City of Bartlett

Municipal Planning Commission

AGENDA

Tuesday, August 5, 2024 - 6:30 P.M.
Bartlett City Hall Assembly Chamber
Staff Comments

CONSTRUCTION DRAWINGS
AUSTIN PLANNED DEVELOPMENT

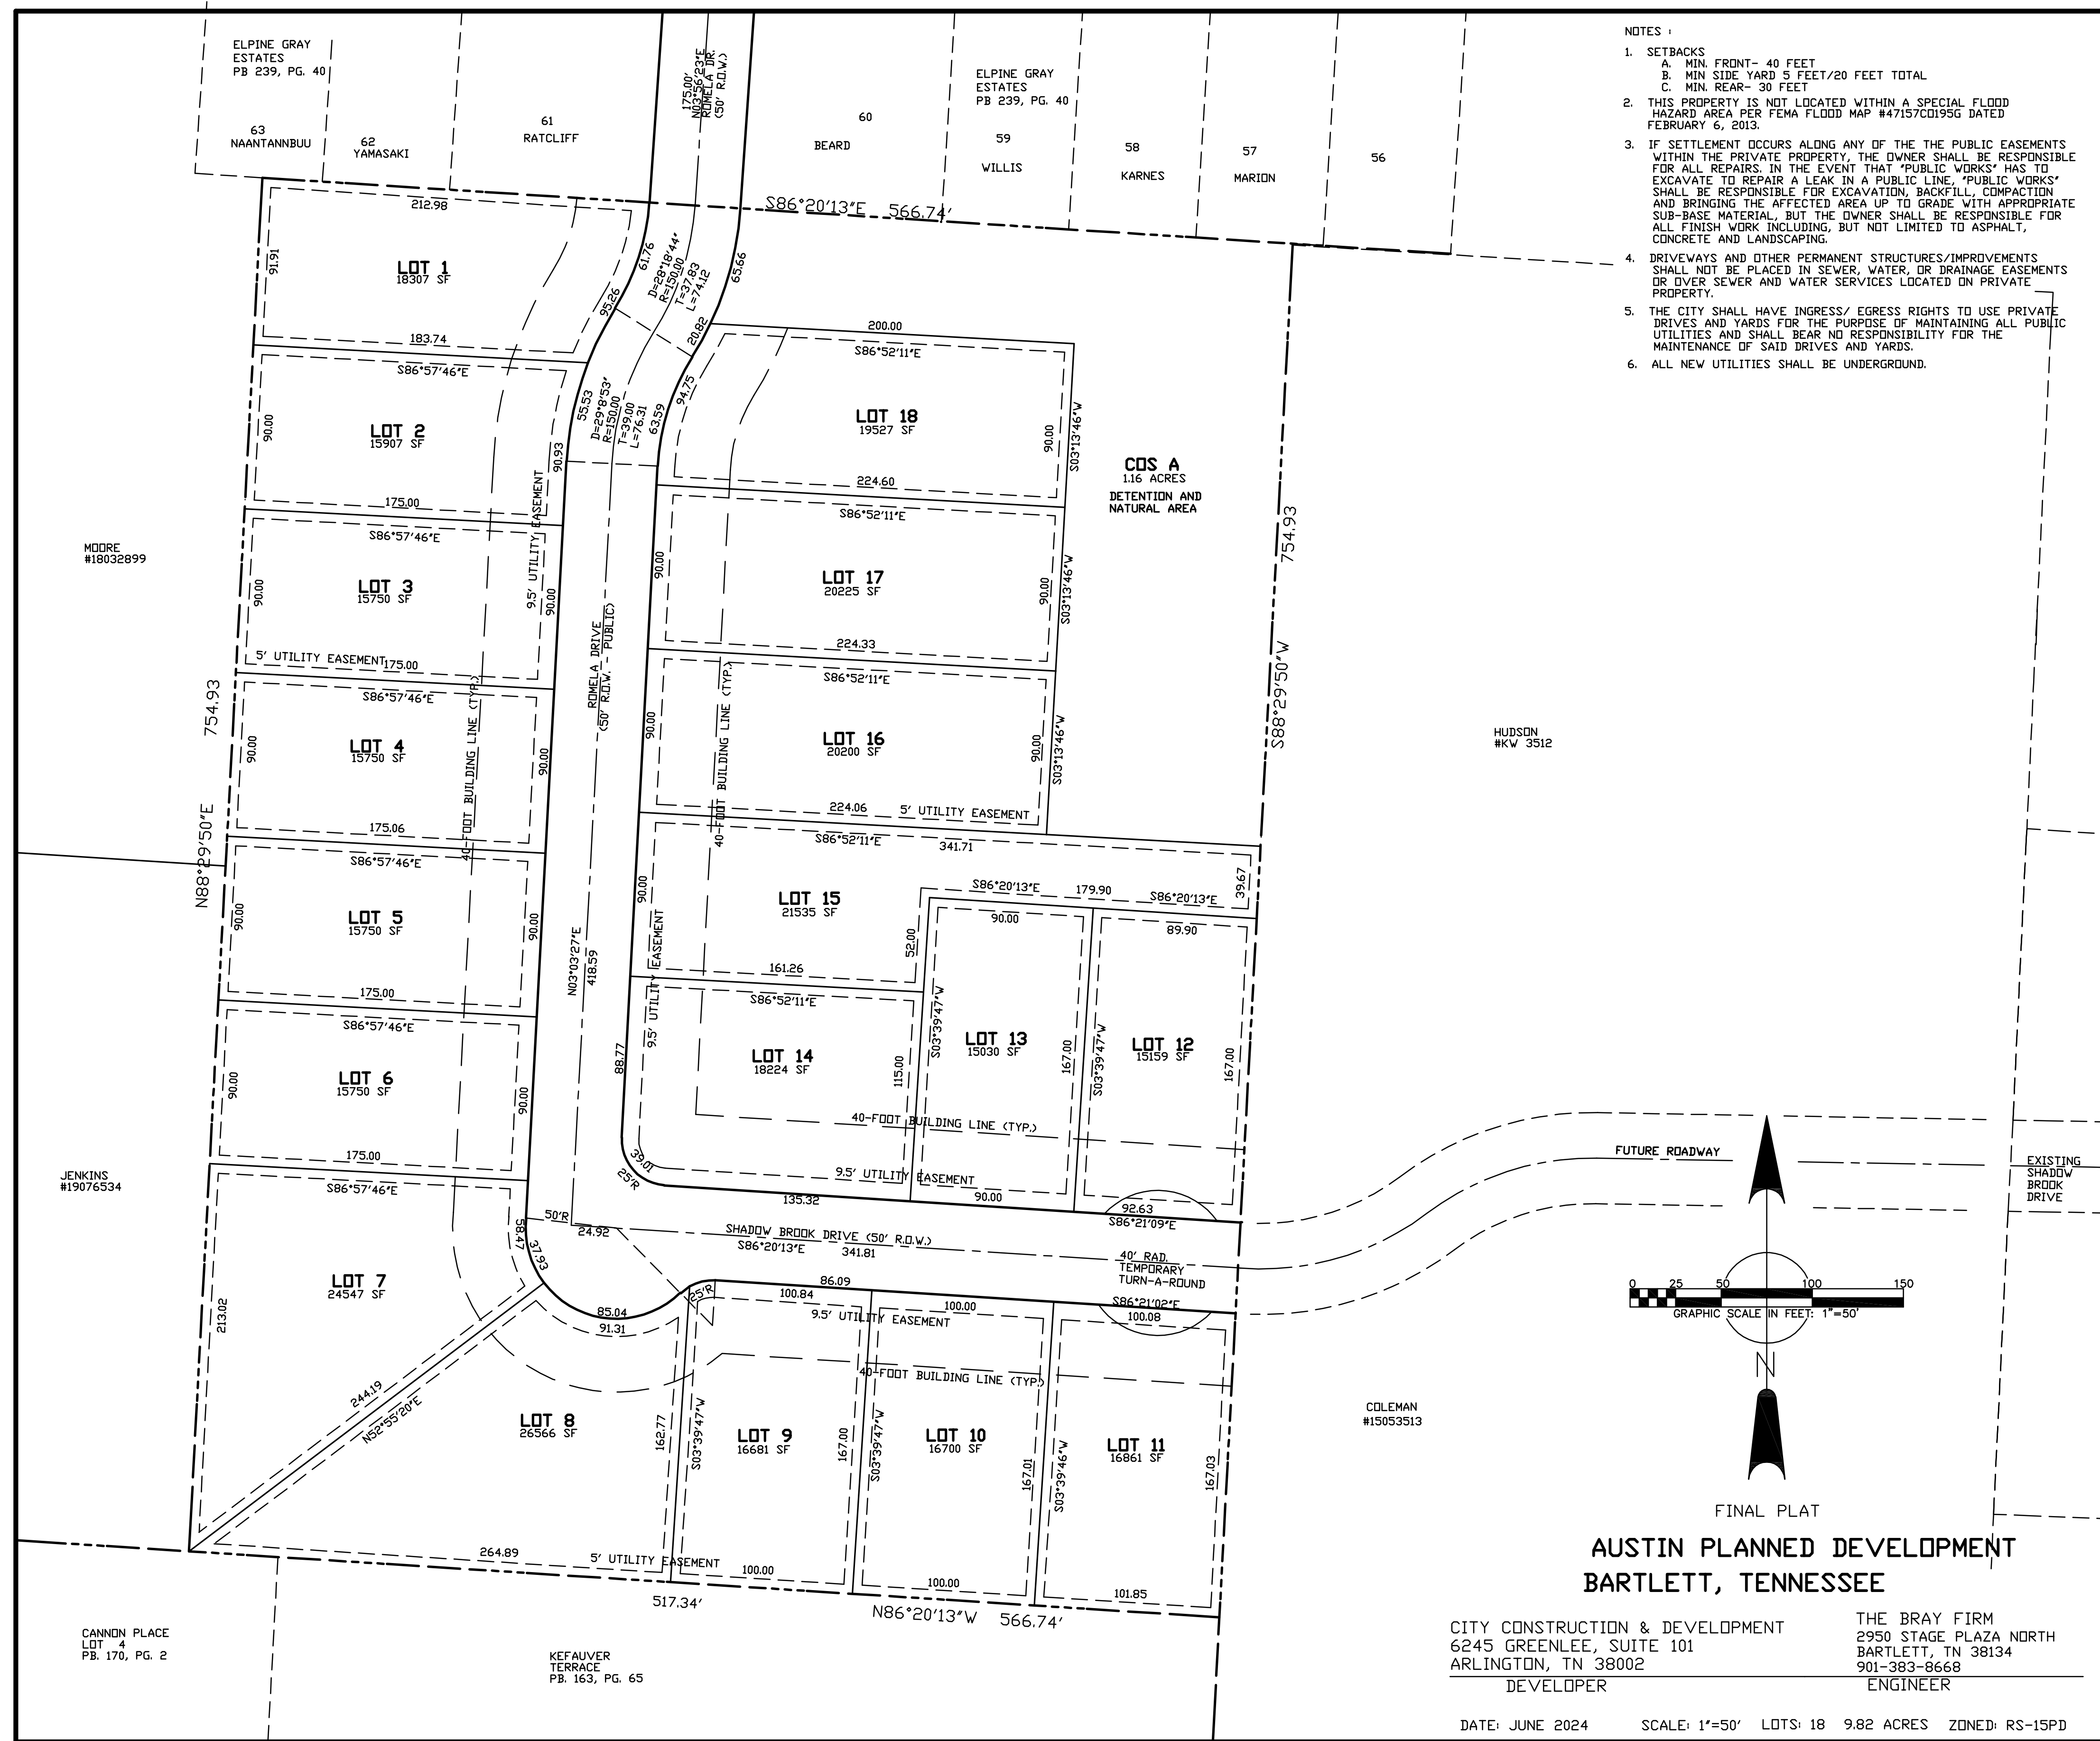
1. A full subdivision contract will be required.
2. All new utilities shall be underground.
3. Handicap ramps are required at street corners.
4. An existing survey/conditions page should be added.
5. This project will not be approved until the required easements from adjacent properties have been obtained and recorded.
6. Easements should be included on all sheets.
7. Plan and profile sheet for off street drainage will be required.
8. Sidewalks for common open space need to be installed before release to buildings.
9. Address all markups.

10. A sidewalk chart needs to be added, showing sidewalk width, side and location.
11. Sewer easements needs to be added.
12. Drainage easements need to be added.
13. A temporary easement needs to be added for temporary turn around.
14. A temporary slope easement needs to be added for Lots 11 & 12 for future construction.
15. Show where the permanent SD survey monuments are to be installed.
16. Show COS to be owned and maintained by the HOA.

1. A Planned Development usually provides common amenities. Staff recommends adding a walking trail around the detention basin on the common open space lot.

2. The applicant shall identify the location for the Post Office required cluster box to the final plat.
3. The applicant shall revise the street names to Christian Lane and Shadow Brook Drive.

4. The applicant shall add a note on the plat that directs future action on removing the temporary turnaround should the adjacent large residential lots subdivide and extend Shadow Brook Drive to Shadowlawn Place Subdivision.

5. The applicant shall provide a tree protection data table that complies with the Tree and Landscape section of the Zoning Ordinance.
6. The resident of Lot 60 of Alpine Gray Planned Development (7603 Romero Drive) has identified the 15", 12", 10", and 8" DBH trees adjacent to the property line as hazardous trees, and the resident would like the developer to remove these hazardous trees.
